INDIANA DEPARTMENT OF TRANSPORTATION

June 17, 2010 Standards Committee Meeting

RE: Agenda for the June 17, 2010 Standards Committee Meeting

ADDED FIGURE 77-4H TYPICAL WIRELESS VEHICLE DETECTION SYSTEM DESIGN (DRAFT)

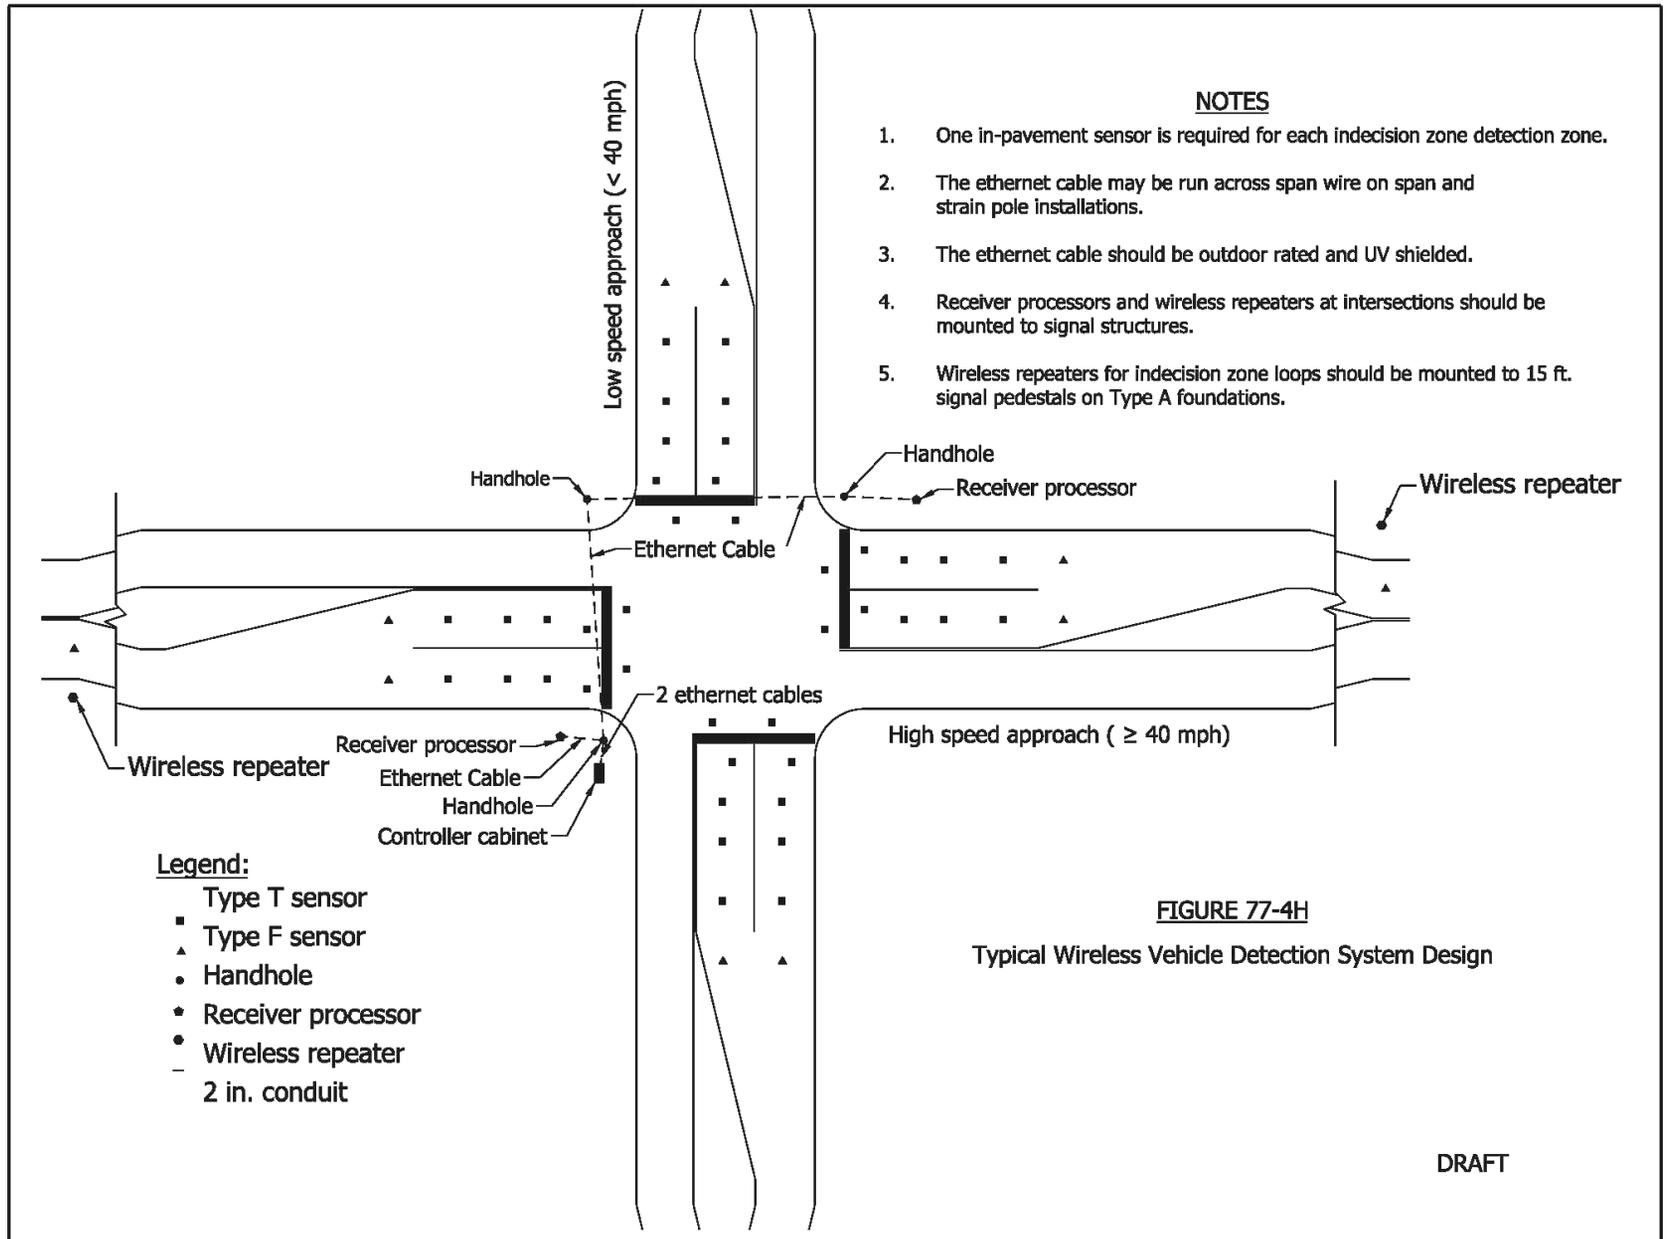
Detection systems other than inductive loops require a specialized design. In order to use a type of detection other than inductive loops, INDOT designers and consultants and local agency consultants must provide and submit documentation that 2 of the following 3 conditions have been met:

PROPOSED NEW STANDARD DRAWING 805-SGDW-01 WIRELESS VEHICLE DETECTORS STOP BAR DETECTION ZONE (DRAFT)

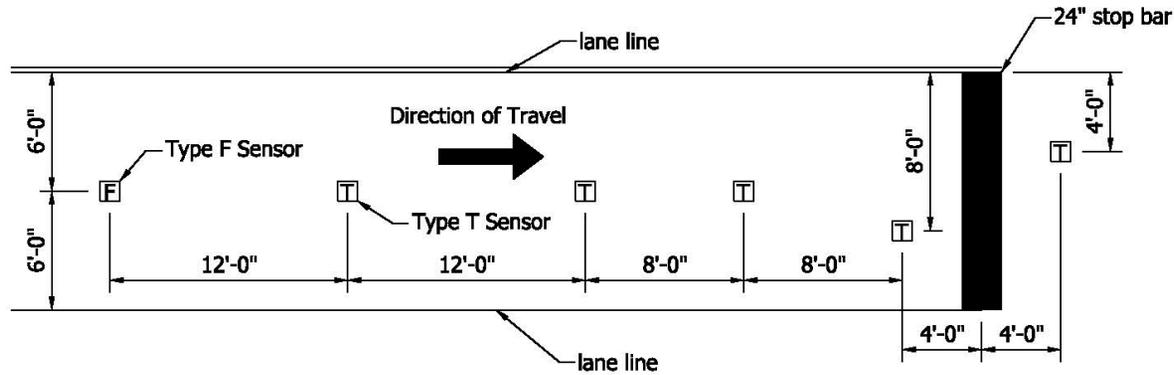
1. Six in-pavement sensors are required for each stop bar detection zone.
